ADDENDUM NO. 2
TO THE
DRAWINGS AND SPECIFICATIONS
FOR THE
SOUTH WALNUT STREETScape ANS STORMWATER IMPROVEMENTS PROJECT
PW2012-10

ISSUED FROM: CITY HALL AT THE SHOWERS BUILDING
Post Office Box 100
401 North Morton Street
Bloomington, Indiana 47404

ISSUE DATE: January 9, 2012

Sheet No. 15
Drawing No.

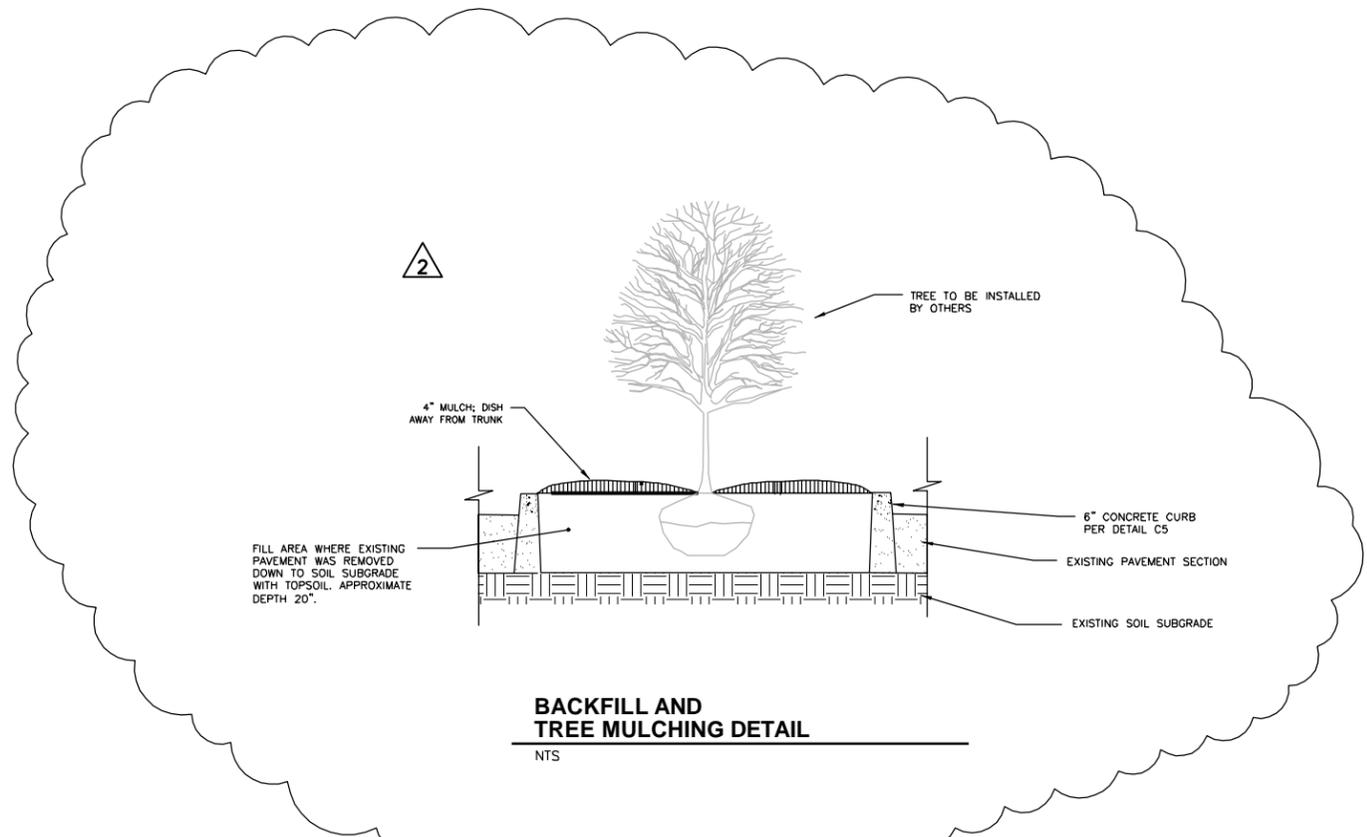
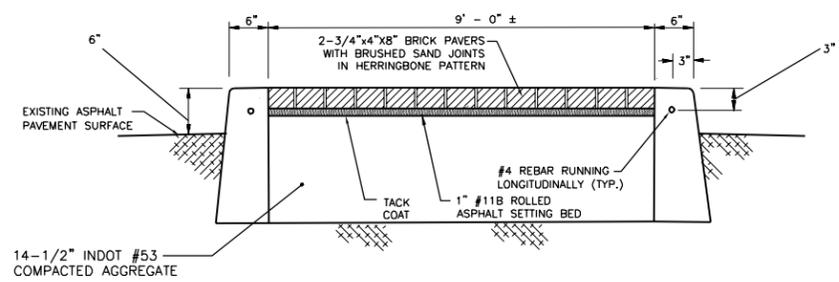
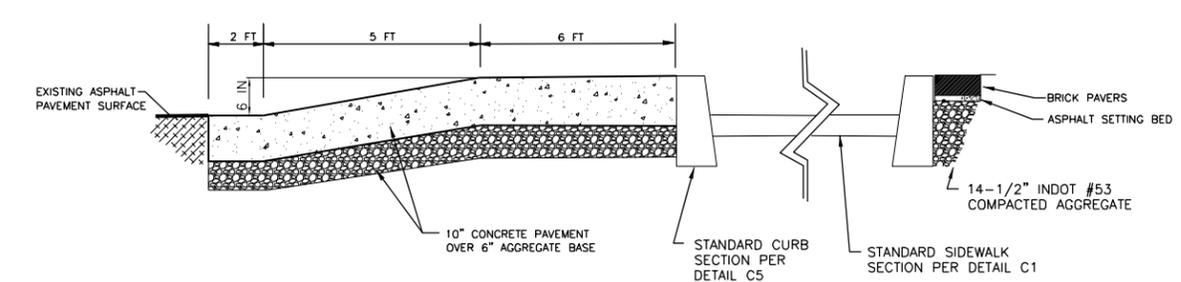
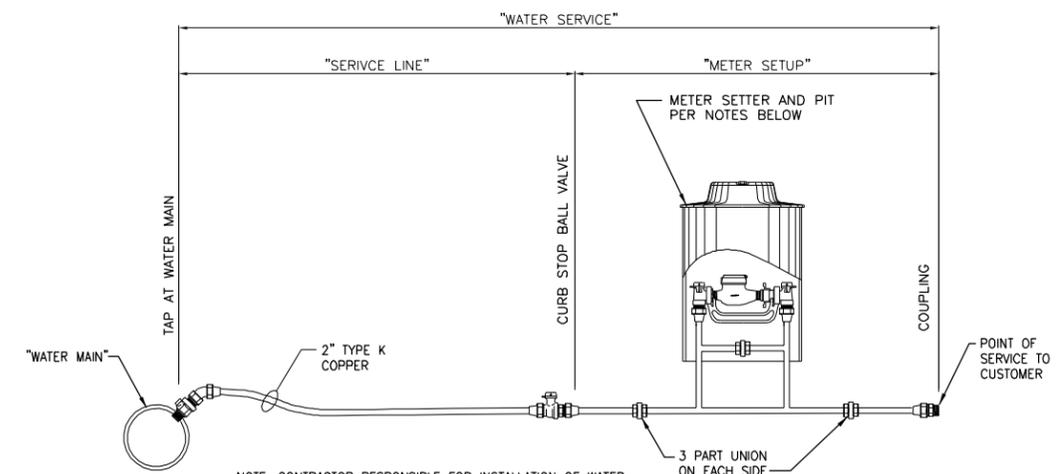
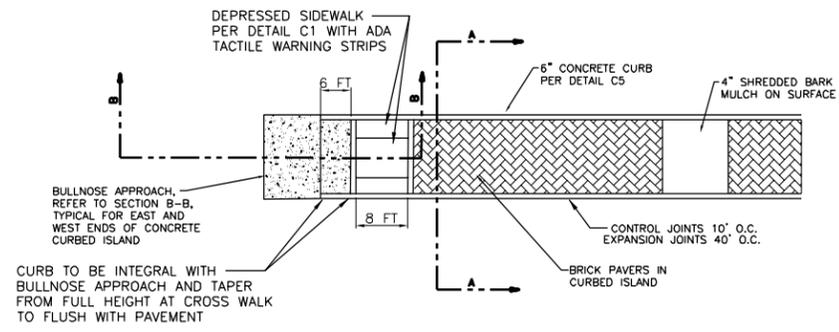
4. Sheet 15, Drawing M3: is deleted and a revised Sheet 15 is attached

NOTE: CONTRACTOR RESPONSIBLE FOR INSTALLATION OF WATER SERVICE AS SHOWN ABOVE

1. METER SETTER SHALL BE: FORD 2" COPPER SETTER (CATALOG #VBHH77-21HBHC-11-77) AND INCLUDE HIGH BYPASS LINE PER MANUFACTURER.
2. TOP OF YOKE TO BE SET MIN. 18" AND MAX 24" BELOW SURFACE GRADE.
3. METER PITS BY WATERWORKS 30"x30" PLASTIC WITH (CBU IJ-7) EXTENSION RING 20"x30" (FORD FL-30) AND (CBU IJ-109) ROUND PIT RING AND #10 LID (FORD #10 LID AND RING) ALL METER LIDS TO BE 20" IN DIAMETER.
4. CBU TO INSTALL METER ONCE SETTER AND PIT ARE INSTALLED BY CONTRACTOR.

CITY OF BLOOMINGTON
 WALNUT STREETSCAPE
 CONTRACT B
 BLOOMINGTON, INDIANA
 MISCELLANEOUS DETAILS
 ELECTRICAL CONNECTIONS

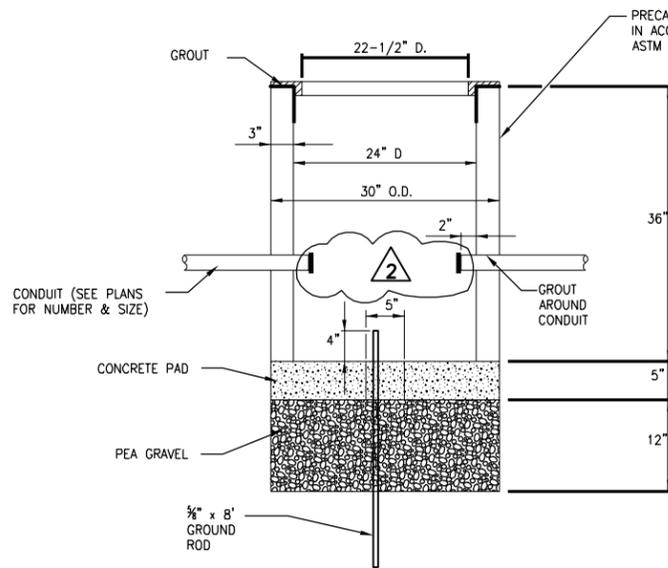
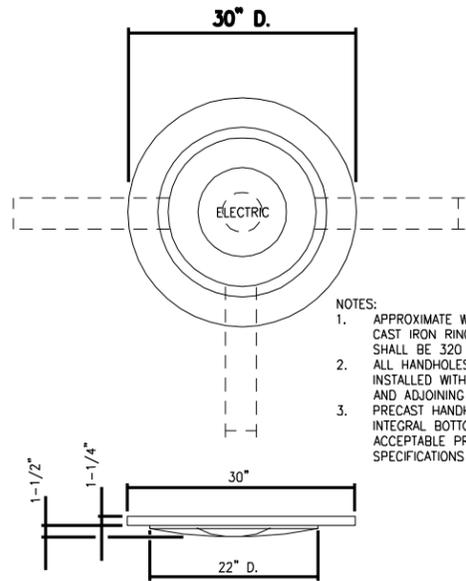
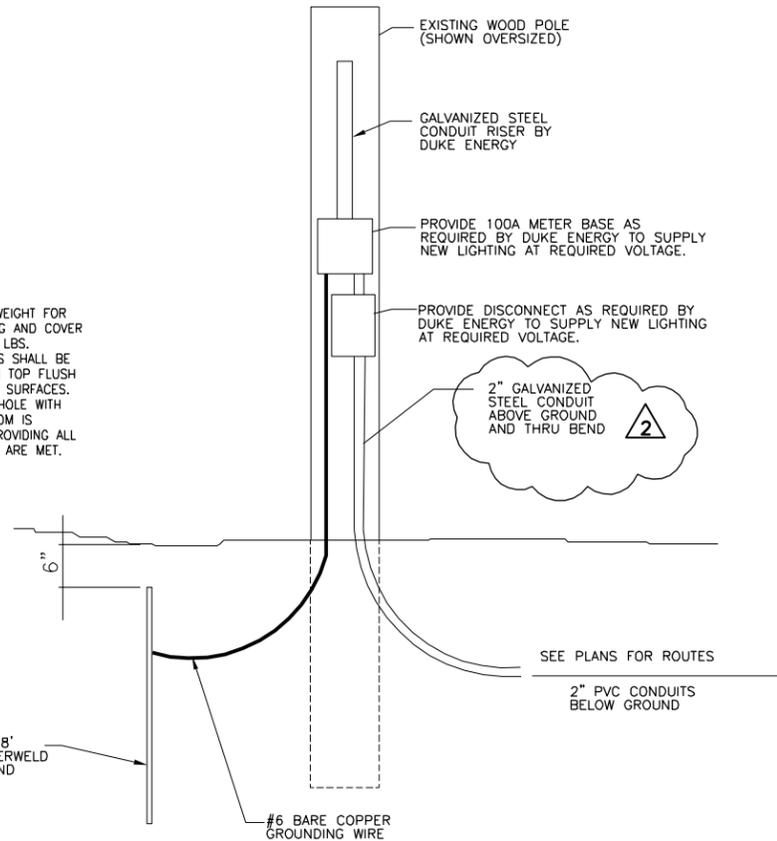
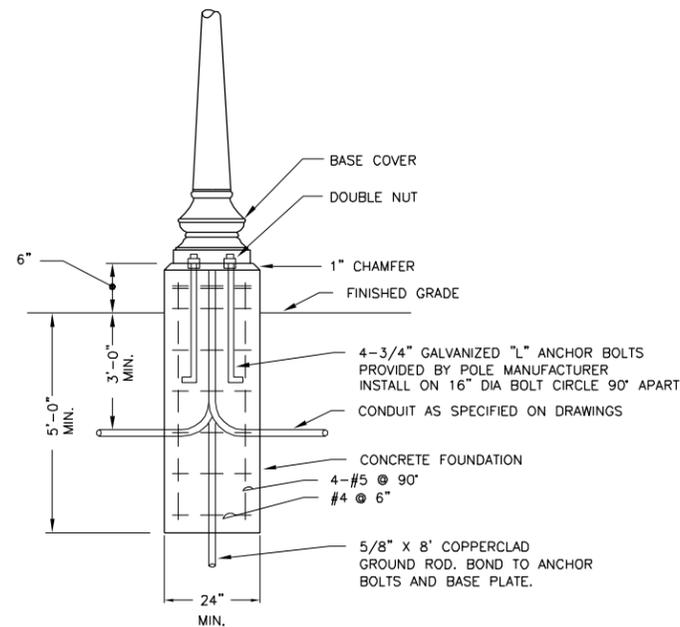
5. Sheet 16, Drawing M4 is deleted and a revised Sheet 16 is attached

1. CONTRACTOR SHALL PROVIDE NECESSARY MATERIALS FOR MOUNTING ELECTRICAL EQUIPMENT TO EXISTING WOOD POLE.
2. THE SERVICE POINT FOR THE NEW LIGHTS ALREADY HAS AN AREA LIGHT ON IT. CONTRACTOR TO COORDINATE WITH DUKE TO MAINTAIN SERVICE TO EXISTING LIGHTING.
2. THIS DETAIL FOR CONCEPTUAL USE ONLY. CONTRACTOR SHALL COORDINATE THE REQUIREMENTS IN THESE PLANS AND SPECIFICATIONS WITH THE EQUIPMENT THEY INTEND TO USE AND ARE TO SUBMIT A SERVICE POINT LAYOUT DRAWING FOR REVIEW BY DUKE ENERGY.

SERVICE PEDESTAL SHALL BE TESCO CONTROLS MODEL 26-000, OR EQUAL, SUITABLE FOR 100 AMP 240 VOLT SERVICE. METER SOCKET NOT REQUIRED IF METER INSTALLED AT SERVICE POINT. CIRCUITS TO BE AS SHOWN IN TABLE BELOW. SERVICE PEDESTAL TO CONTAIN LIGHTING CONTACTOR AND PHOTOCELL CONTROLS FOR ALL LIGHTING CIRCUITS. CABINET SHALL BE HOT DIPPED GALVANIZED STEEL FINISHED OR PAINTED IN COLOR SELECTED BY CITY. ENCLOSURE DOOR SHALL BE HINGED WITH PADLOCKABLE LATCH AND NO EXPOSED NUTS, BOLTS, SCREWS, OR OTHER FASTENERS.

1. ALL CONDUITS ARE TO BE 2" PVC SCH. 80 AND ARE TO BE BURIED 36" DEEP. ADVISE ENGINEER IF DIFFERENT DEPTS REQUIRED DUE TO CONFLICTS.
2. LIGHTING CIRCUITS TO BE LABELED ACCORDING TO PHASE AND CIRCUIT NUMBER AT EACH LIGHT POLE.
3. SEE PLANS FOR LOCATIONS OF CONDUIT.

STREET LIGHTING AND
 CONCRETE PAVEMENT JOINT PLAN

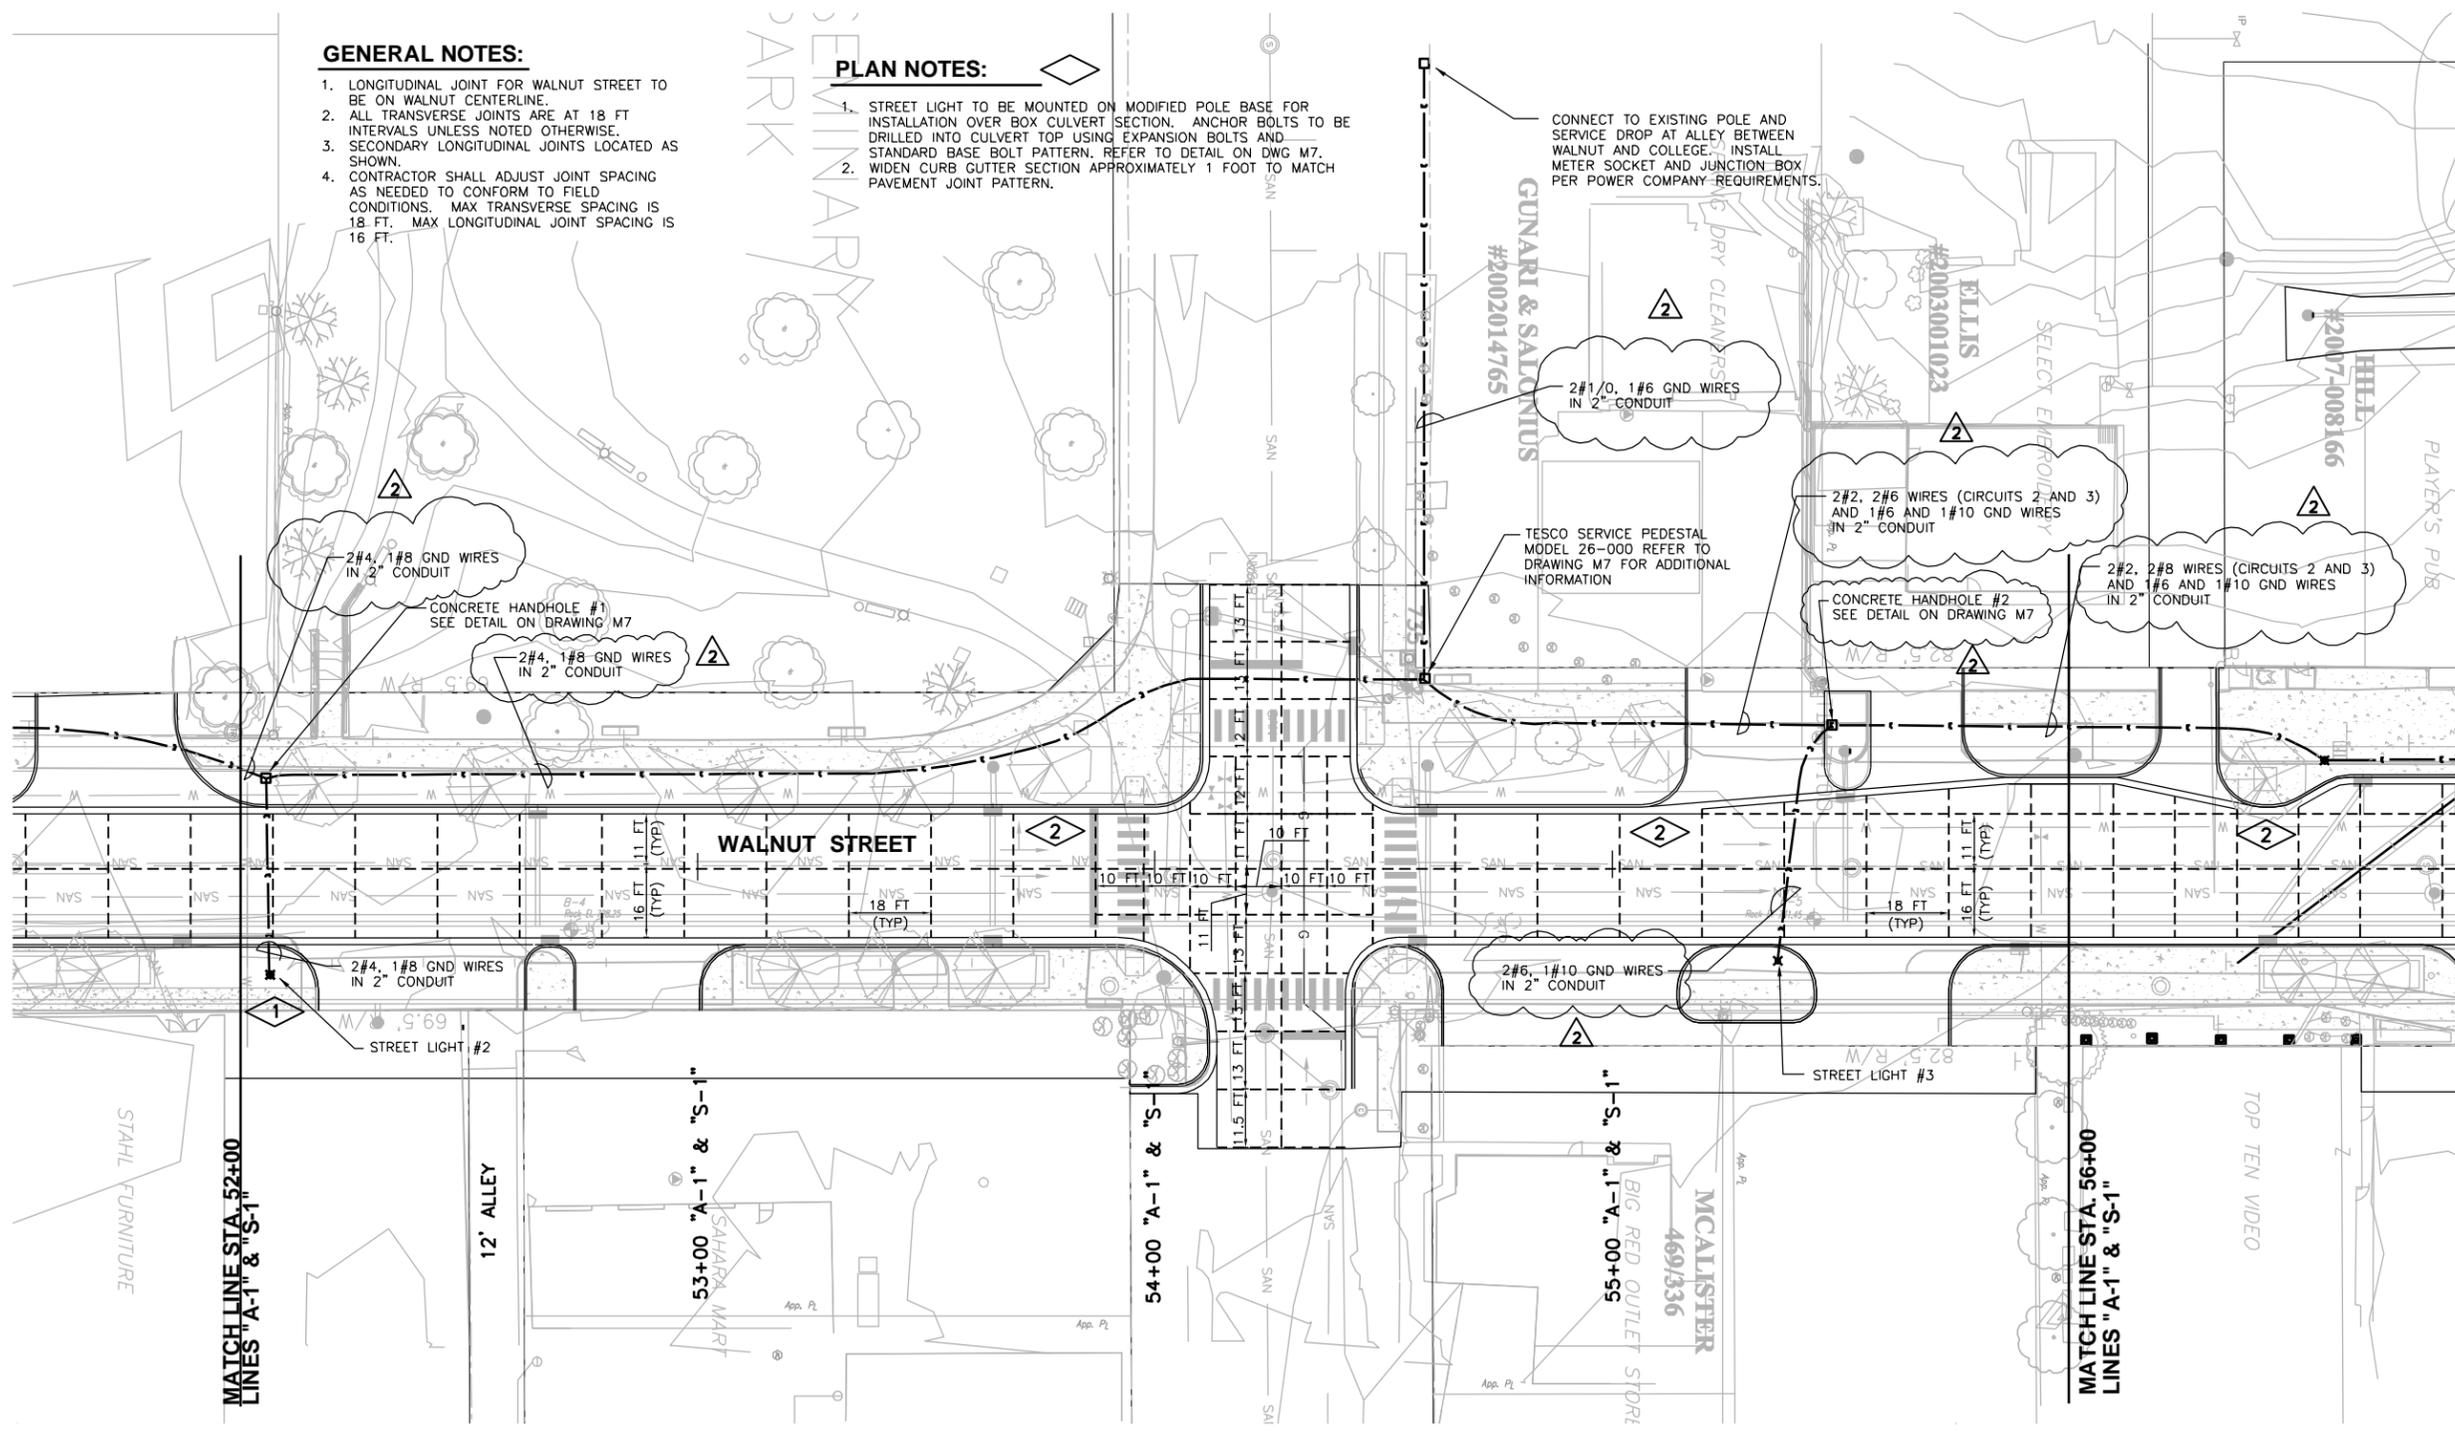
8. Sheet 32, Drawing PJ2 is deleted and a revised Sheet 32 is attached
9. Sheet 33, Drawing PJ3 is deleted and a revised Sheet 33 is attached
10. Sheet 37, Drawing M4. The Contractor will install the irrigation system as shown on the plans, except for the Quick Coupler Valve and Valve Box. The Contractor will install the irrigation lines into the raised planters as shown and cap line in place inside planter box. Suitable soil shall be placed in the planter boxes up to a level 2 feet below the top of the box.

1. STREET LIGHT TO BE MOUNTED ON MODIFIED POLE BASE FOR INSTALLATION OVER BOX CULVERT SECTION. ANCHOR BOLTS TO BE DRILLED INTO CULVERT TOP USING EXPANSION BOLTS AND STANDARD BASE BOLT PATTERN. REFER TO DETAIL ON DWG M7.
2. WIDEN CURB GUTTER SECTION APPROXIMATELY 1 FOOT TO MATCH PAVEMENT JOINT PATTERN.
